**Objection to Planning and Conservation Area Consent Applications  
The Waterhouse (Ref: 2011/4390/P and 2011/4392/C)**

**Notes on Landmark Trees Arboricultural Impact Assessment Report (AIA) for Waterhouse, Millfield Lane, London, N6 6HT**

Figure 1: Circa 1860's ordnance survey map of Millfield Lane showing existing trees superimposed over current aerial photograph (2009) with Waterhouse and oak tree marked with arrows.

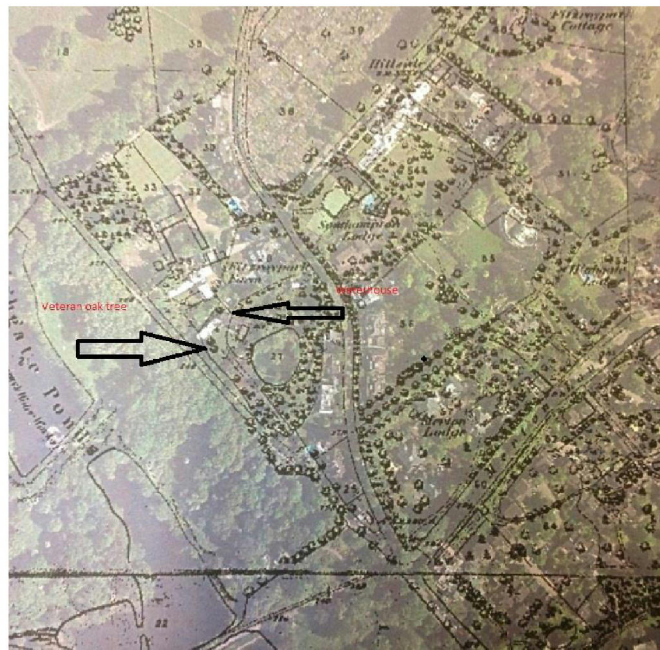
The oak tree (T5) which should be referred to as a veteran tree, is probably a survivor of a remnant of woodland that still existed in the 1870's. In previous documents commenting on the earlier planning application this was pointed out and an ordnance survey map from the period was included showing the possible tree marked on the map. From the size of the main stem (1300mm) the tree is somewhere between 200 to 250 years old but could possibly be older. Aging trees is a notoriously difficult exercise due to misunderstanding about differences in environmental conditions. An oak tree growing in woodland will grow at roughly half the rate of a tree growing in parkland or woodland pasture. If the tree in question spent its early developmental stage in a woodland environment it is likely to be 250 years or older. The oak tree should be recognised as veteran status but this is not mentioned and this is failing to recognise its heritage and conservation value. See map below.

**Figure 1: Circa 1860's ordnance survey map of Millfield Lane showing existing trees superimposed over current aerial photograph (2009) with Waterhouse and oak tree marked with arrows.**

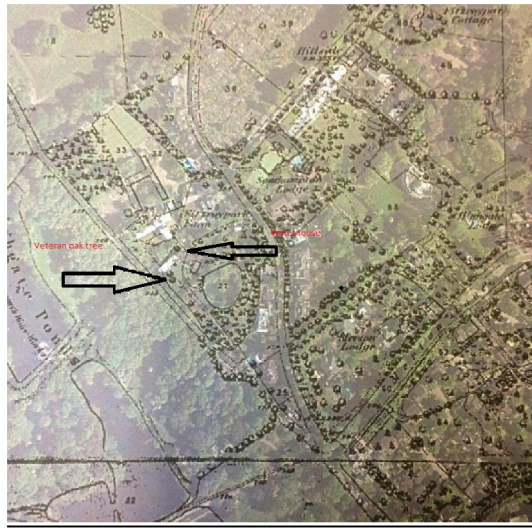
The image below provides evidence of the treescape in the 1860's and allows identification of the trees that have survived from that period including a number of what are now classified as Veteran Trees. In the 1860's these trees were part of remnant woodlands and old field boundaries. The map is overlaid over a recent aerial photograph (2010) and the existing properties in the Millfield Lane area can be seen including the Waterhouse (marked). This information is provided to give some historical reference to the area and to highlight the importance of the remaining veteran trees still growing along Millfield Lane and also in a number of the properties, including the fine oak growing in the garden of the Waterhouse. Hampstead Heath has approximately 800 Veteran trees scattered across its 275 hectares, many of which are old field boundary trees, dating back to the nineteenth century and earlier when the Heath was still farmland.

The Waterhouse oak is probably about 250 years old, as it appears as a mature tree in the 1860's. The tree has a number of veteran features including decay pockets in the base and the crown break ;both mentioned in the BS:5837 survey carried out by Landmark Trees. It has a DBH of 1290 which compares with some of the largest veteran trees on the Heath and although it clearly has some structural issues it is in good physiological condition, with a large extended crown and good crown density with no sign of any significant die back.
